**SANTA CRUZ COUNTY  
GROUP**

**Re: Santa Cruz Wharf Master Plan Draft Environmental Impact Report (DEIR)**

### **BIO-1c Effects on Wildlife Populations**

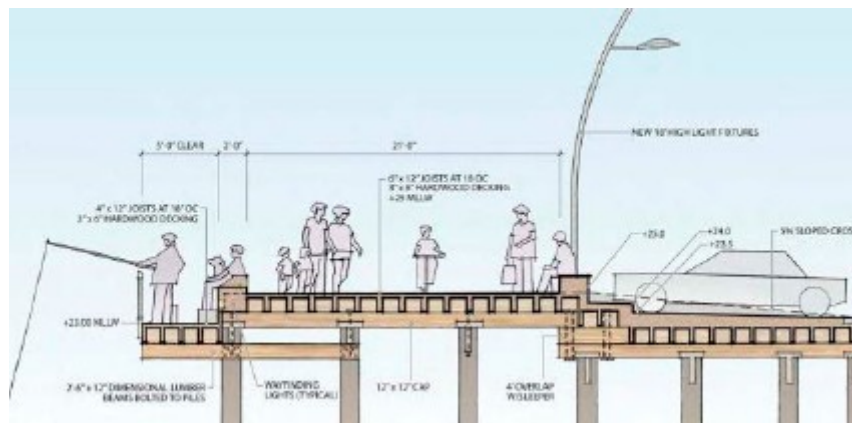
Of concern is the statement that the “Master Plan includes a new boat landing for research and visitor vessels. At this time it is not known when this facility may be developed”. Based upon this temporal ambiguity, the DEIR then appears to brush off any concerns related to increased boat traffic. As it is not known when all aspects of this plan may be developed, the statement referred to above is inappropriate. Should the Wharf, for example, seek to host tenders from cruise ships in the future, impacts from this new boat landing may indeed be significant. We request that a proposed, stated, level of boat traffic be included for this analysis, and that any increase above that level be required to trigger new environmental review. With the proposed use of this boat landing for 200 ton displacement vessels, the DEIR should include analysis of the impacts on wildlife of this use, done by qualified personnel.

### **TRAF-1 Conflict with a Program - Bicycle**

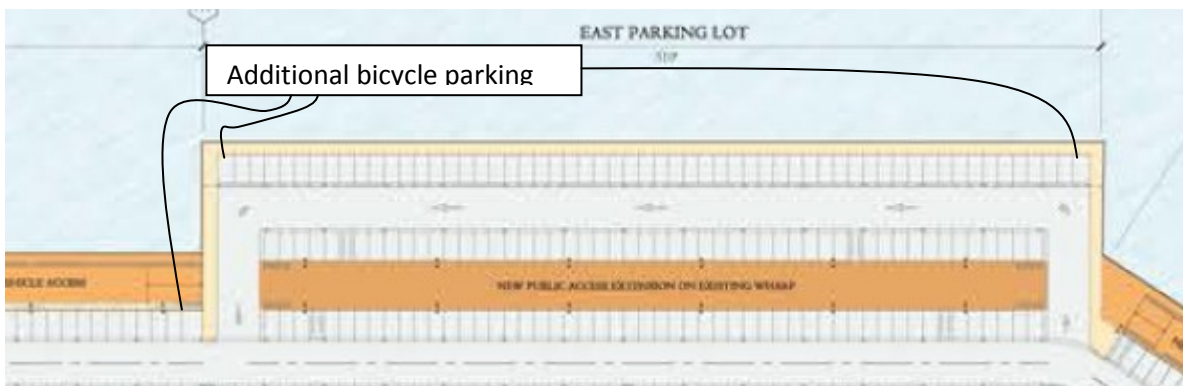
The Sierra Club appreciates and applauds the proposed design for its large bicycle and pedestrian walkway, as seen here:

This can give the impression that the Plan takes bicycle transportation seriously. Access is only a portion of visiting the Wharf by bicycle. The design fails to provide adequate bicycle parking. City of Santa Cruz Ordinance No. 2017-02 requires that public or commercial recreation uses have a number of parking spaces of at least 35% of the auto parking spaces. The design calls for 64 bicycle parking spaces yet 495 auto parking spaces – 12.9% Although mention is made of providing more spaces in the future, how and where these spaces will be is of concern. Namely, whereas all of the auto parking spaces are designed in and indicated, the future bicycle spaces are not, and then evidently must be taken from areas already identified for pedestrian and bicycle use. A Plan without the full amount of required spaces is in conflict with the City requirements; but even if it were not the proposed 64 spaces indicates that bicycle parking is an afterthought in this Plan. We strongly recommend that all corner areas currently designated for auto parking be instead allocated for bicycle parking, so that proper accommodation of bicycles may be achieved:
